# $V_{CC}$ vs System Speed of MSP430F21x1

This document provides analysis details and specific results of the CPU45 errata affecting the following devices:

- MSP430F2131
- MSP430F2121
- MSP430F2111
- MSP430F2101

**Figure 1. Recommended Operating Conditions for System Frequency vs Supply Voltage**

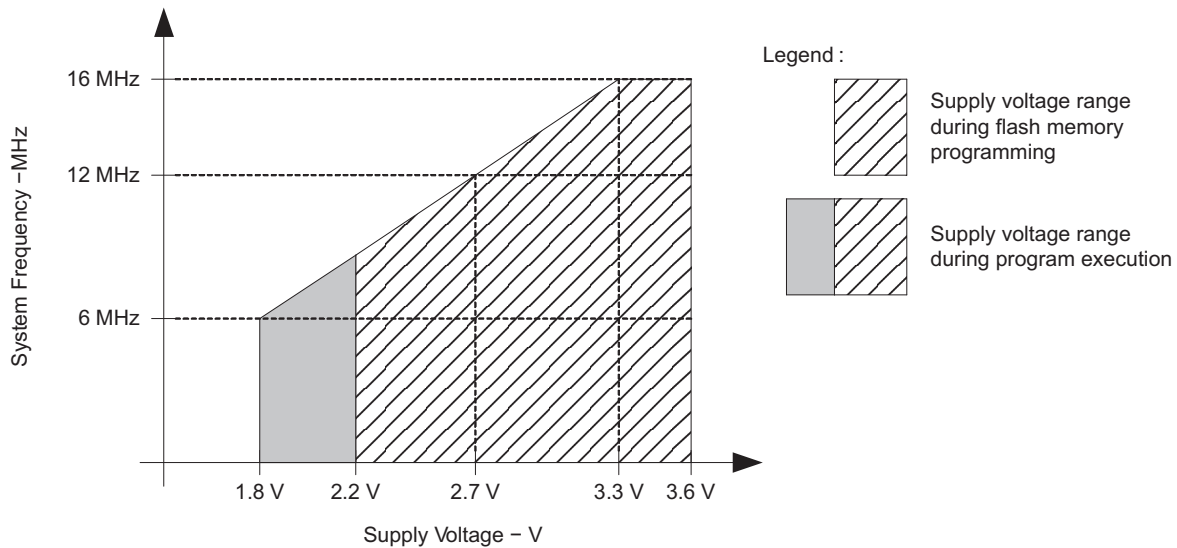
The system speed performance above 4.15 MHz versus minimum required  $V_{CC}$  as shown in Figure 1 from the data sheet can be met under certain specific conditions only. If these conditions are not fulfilled, the CPU status register and R4 through R15 register contents may become unintentionally changed during some CPU register operations. This behavior is dependent on voltage, frequency, and clock duty cycle with certain operand and instruction combinations. Such code sequences are common in C-compiler generated application code.

Figure 2. V<sub>CC</sub> vs Frequency – Safe Operating Conditions for LFXT1 in HF Mode and for Digital External Clock Sources

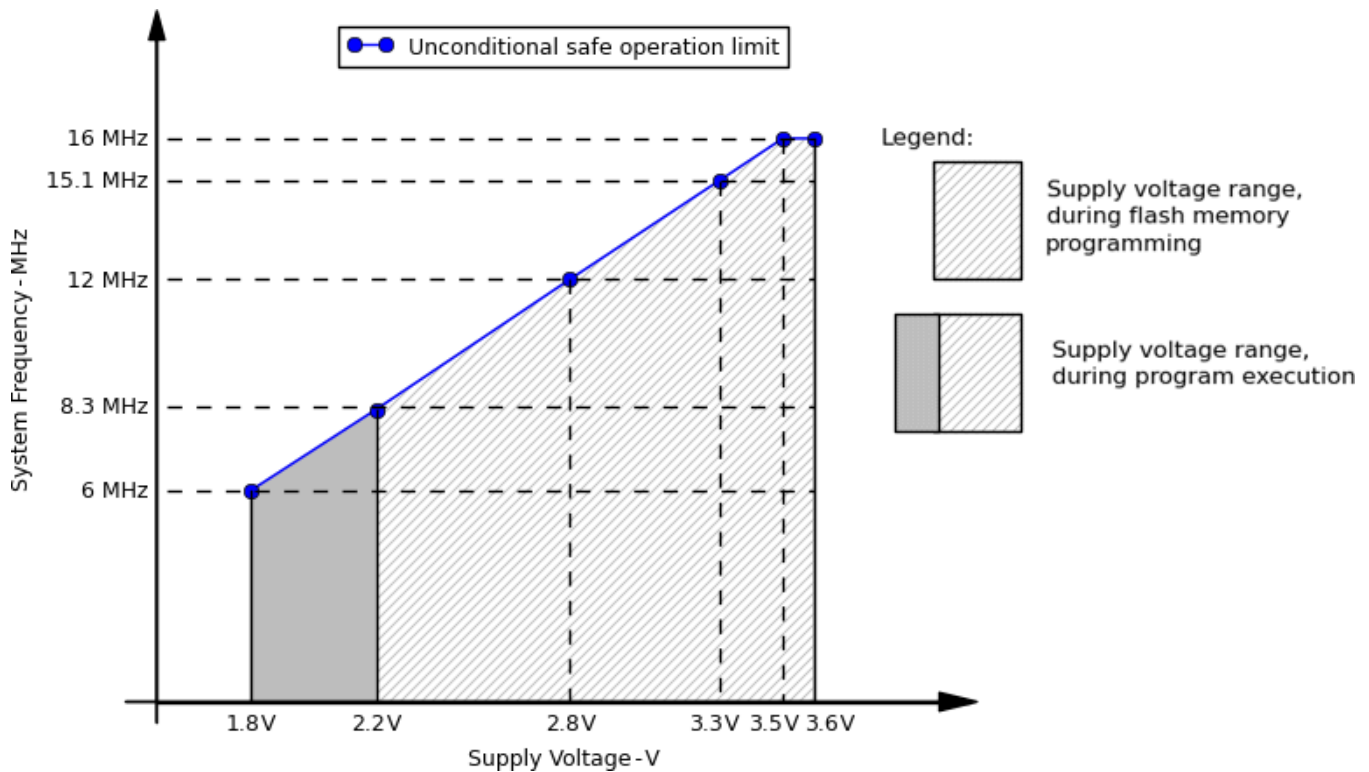
Figure 2 shows the safe operation area for the system clock (MCLK or CPU clock) when using an external clock or the device HFO without an internal clock divider.

- Use only the DCO as the clock source for the system frequency (MCLK or CPU clock).
- Reduce the system frequency (MCLK or CPU clock) according to the V<sub>CC</sub> vs frequency graph shown in Figure 2.
- Increase V<sub>CC</sub> according to the V<sub>CC</sub> vs frequency requirements as shown in Figure 2. Do not exceed the *Recommended Operating Conditions* as stated in the data sheet.
- Use internal dividers for the MCLK clock sources.
- Use external clock generators that provide a 50% or higher duty cycle.
